# UNITED STATES PATENT AND TRADEMARK OFFICE

10/601,596

**Office Action Summary**

### **DETAILED ACTION**

**Exhibit A**

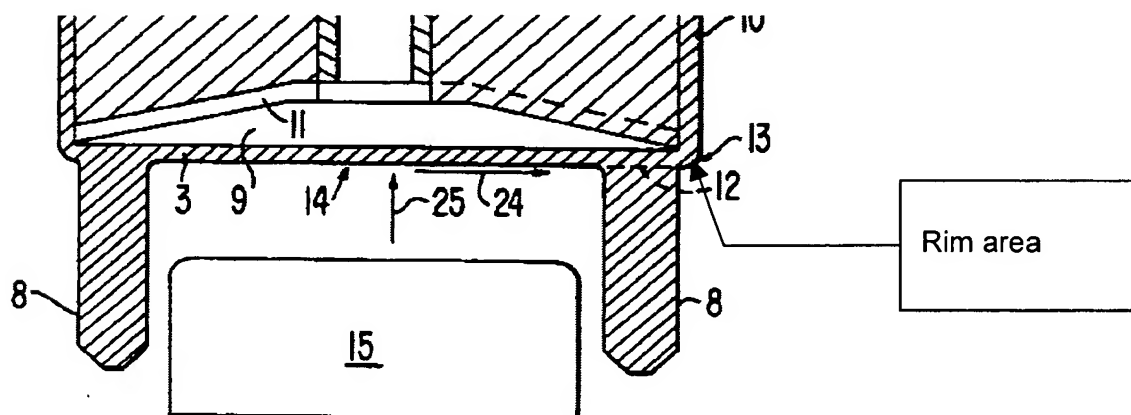
Applicant argues that "Breu clearly fails to disclose an elastic area comprising both a rim area and a deformable area" (last paragraph of page 5). Applicant recites "at least one elastic layer which is a thin layer with a rim area surrounding a deformable area; two sides of said elastic layer defining an upper surface and a lower surface" in claim 1, lines 2-4. Breu et al. (5,263,753) discloses at least one elastic layer, a flexible membrane (3) with a rim area surrounding the deformable area (see Exhibits A and Exhibit B below). Note that applicant does not clearly define "the deformable area".

Applicant also argues that "Breu fails to disclose a supporting mechanism anchored to the elastic layer at the rim area" (3<sup>rd</sup> paragraph of page 6). The argument is not persuasive. Exhibit A shows that a supporting mechanism (2) is being substantially anchored to the elastic layer at the rim area. Also note again the applicant fails to clearly define the "boundary of the rim area". Therefore, Breu et al. device (5,263,753) meets the claim.

shows a hollow tube (2) having a rim of a cross section of said hollow tube being fixed to said rim area of said upper surface of said elastic layer as shown in Exhibit A.

**Exhibit B**

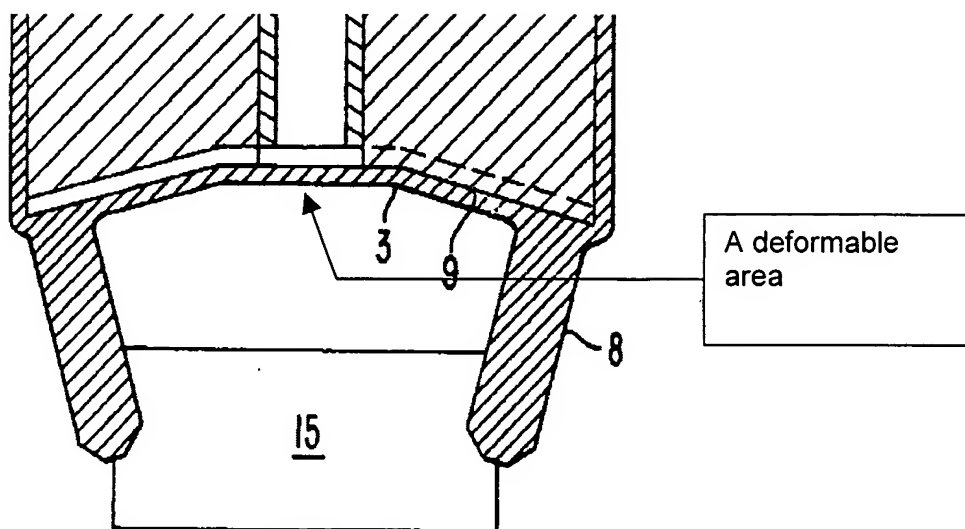
Exhibit B shows a deformable area (in the middle portion) and a rim area substantially surrounding the middle deformable area. Note that the rim area can be defined as an area that surrounds the deformable middle area.
